INTERNATIONAL STANDARD ISO/IEC/IEEE 8802-1AX:2016
TECHNICAL CORRIGENDUM 1

Part 1AX: Link aggregation

TECHNICAL CORRIGENDUM 1

**IEEE Standard for
Local and metropolitan area networks—
Link Aggregation—Corrigendum 1:
Technical and editorial corrections**

Figure 6-20—Selection of Aggregators

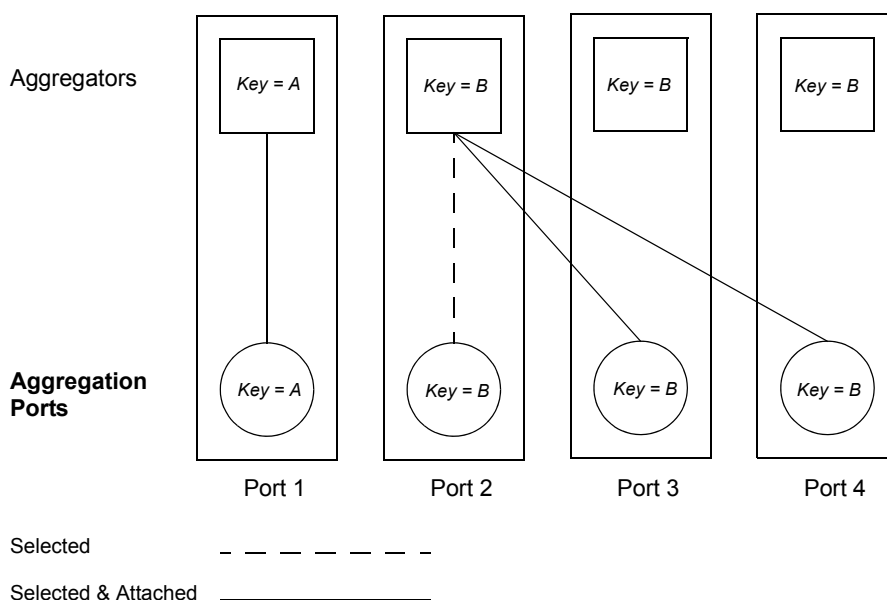
~~Each Aggregation Port has an Aggregator associated with it, (i.e., the number of Aggregators in the System equals the number of Aggregation Ports supported). Each Aggregation Port/Aggregator pair is assigned the same operational Key and Port Number. When there are multiple Aggregation Ports in an aggregation, the Aggregator that the set of Aggregation Ports selects is the Aggregator with the same Port Number as the lowest-numbered Aggregation Port in the aggregation. Note that this lowest-numbered Aggregation Port may not be in a state that allows data transfer across the link; however, it has selected the Aggregator in question. This is illustrated in Figure 6-20. In the default configuration, each Aggregation Port has an Aggregator associated with it (i.e., the number of Aggregators in the System equals the number of Aggregation Ports supported), and each Aggregation Port and each Aggregator is assigned the same operational Key value. This configuration may be altered to assign either of the following:~~

- Different Key values to different sets of Aggregation Ports when it is not possible or not desirable to place Aggregation Ports from the different sets into the same Link Aggregation Group, or
- A given Key value to fewer Aggregators than Aggregation Ports (e.g., to support dual-homed configurations described in 6.7.5).

If the Aggregation Port is Individual, then the Aggregator selected is always the Aggregation Port's own Aggregator. Otherwise, an Aggregator is selected from the set of Aggregators ~~corresponding to the set of Aggregation Ports that will form the aggregation~~ with the same operational Key value as the Aggregation Port. ~~The Aggregator selected is the lowest numbered Aggregator with the same selection parameters as those of the Aggregation Port~~ When multiple Aggregation Ports have the same selection parameters they will select the same Aggregator. These selection parameters are as follows:

Whenever possible, the Aggregator selected is the Aggregator associated with the lowest numbered Aggregation Port in the set with the same selection parameters. Note that this lowest Numbered Aggregation Port may not be in a state that allows data transfer across the link; however, it has selected the Aggregator in question. This is illustrated in Figure 6-20. If it is not possible to select the Aggregator associated with the lowest numbered Aggregation Port (e.g., if the lowest numbered Aggregation Port and its associated Aggregator have different operational Key values), then the Aggregator selected can be any Aggregator with a matching Key value that has not been selected by any Aggregation Ports with Port_Enabled set to True. If such an Aggregator cannot be found, then the Aggregation Port does not select an Aggregator until the situation changes and an appropriate Aggregator can be found.

Figure 6-29—Conversation-sensitive collection state diagram

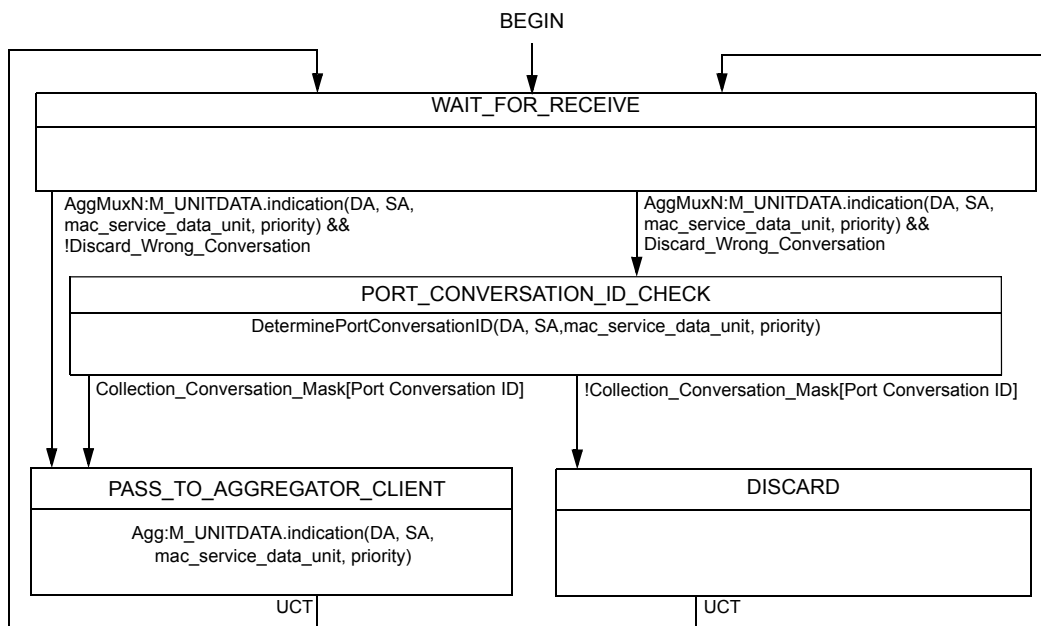
Replace Figure 6-29 with the following:

Figure 6-34—Update Mask state diagram

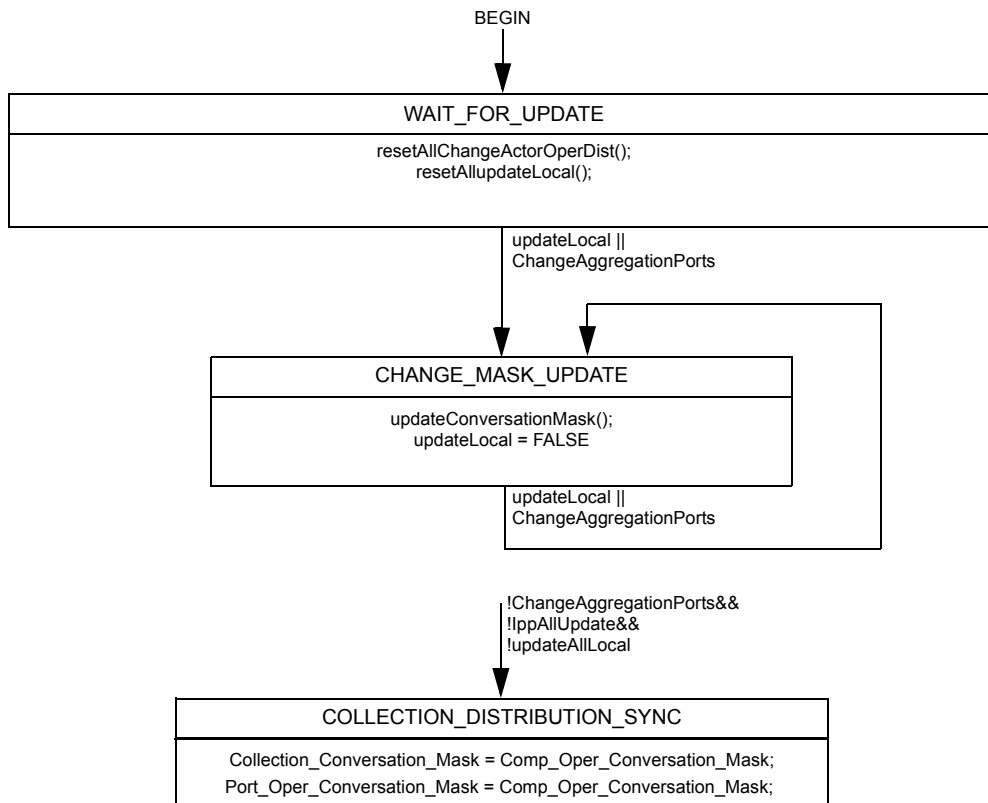
Replace Figure 6-34 with the following:

Figure 6-37—Dual-homed System examples

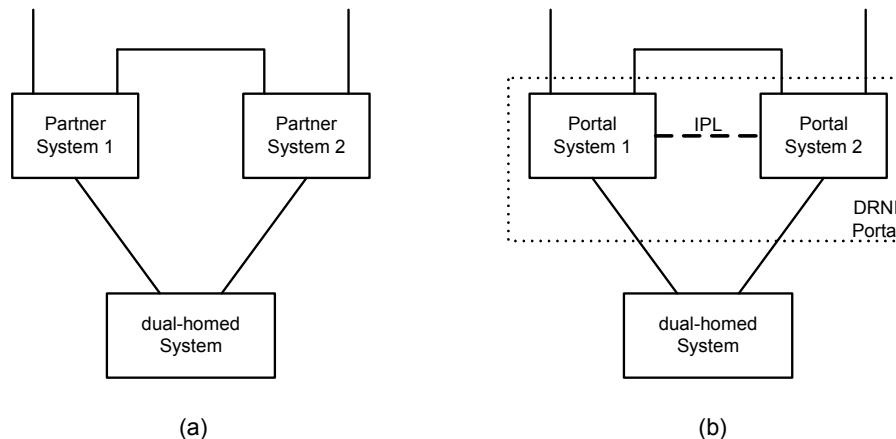
Insert new subclause 6.7.5 as follows:

Figure 6-37 shows two examples of dual-homed systems. In Figure 6-37(a), the dual-homed System is connected to two different Partner Systems. In this case, the two Aggregation Ports cannot select the same Aggregator, and only one Aggregator is available, so the selection logic causes only one Aggregation Port of the set to be selected. The result is a single Link Aggregation Group that includes only one link and connects to only one of the Partner Systems. The Aggregation Port that is not initially selected is held in reserve. Should the link attached to the initially selected Aggregation Port fail, the other Aggregation Port will be selected for a new Link Aggregation Group that again includes only one link but connects to the other Partner System.

In Figure 6-37(b), the dual-homed System is connected to two different Portal Systems in a DRNI Portal (9.1). The normal DRNI operation allows both Portal Systems to present themselves as a single Partner System with the same Operational Key value on both links, resulting in both links become active in a single LAG. If the Intra-Portal Link (IPL) fails, however, the two Portal Systems will use different Operational Key values, which prevents both links from forming a single LAG. In this case, the restriction that the dual-homed system only has a single Aggregator available for these Aggregation Ports results in one Aggregation Port being SELECTED and the other UNSELECTED.
